MEMORANDUM

RE: Sound Impact Analysis
Violet Hill Pit

FILE: 114-310

Title	Proposed Haul Route	Date	2017-07-06	
	Project Name	Violet Hill Pit/Town of Mono	Project No.	114-310	
				Figure	1

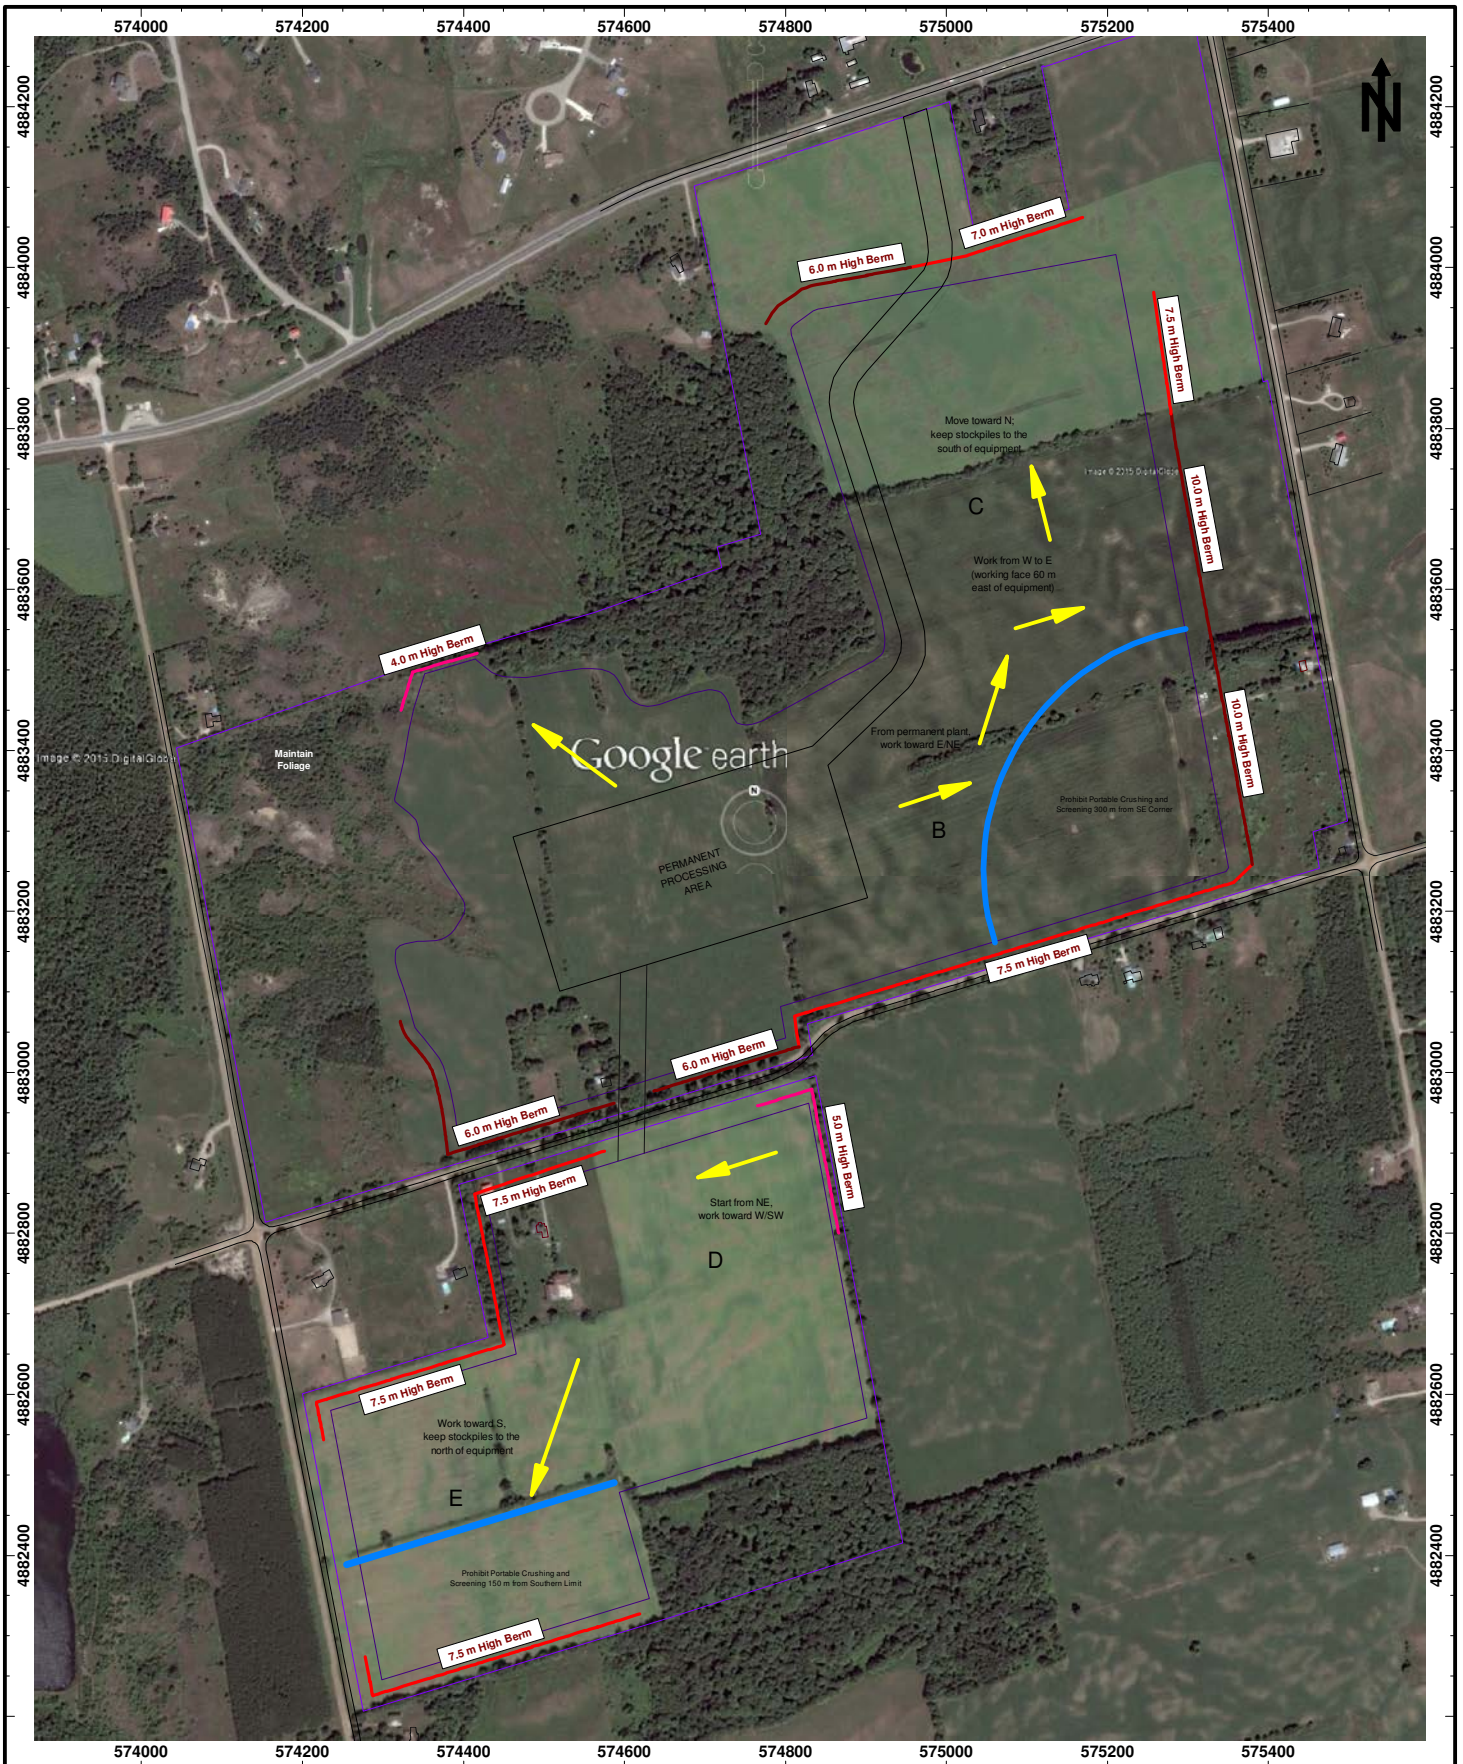
The alternate site entrance location is at 3rd Line East, approximately 500 m south of Highway 89. From this entrance location, trucks will head in southeasterly direction to the west of the permanent processing plant. Our analysis of the revised site entrance location indicates that some additional acoustical screening is required to protect R14. A 4.0 m high berm, as shown on Figure 1, is recommended.
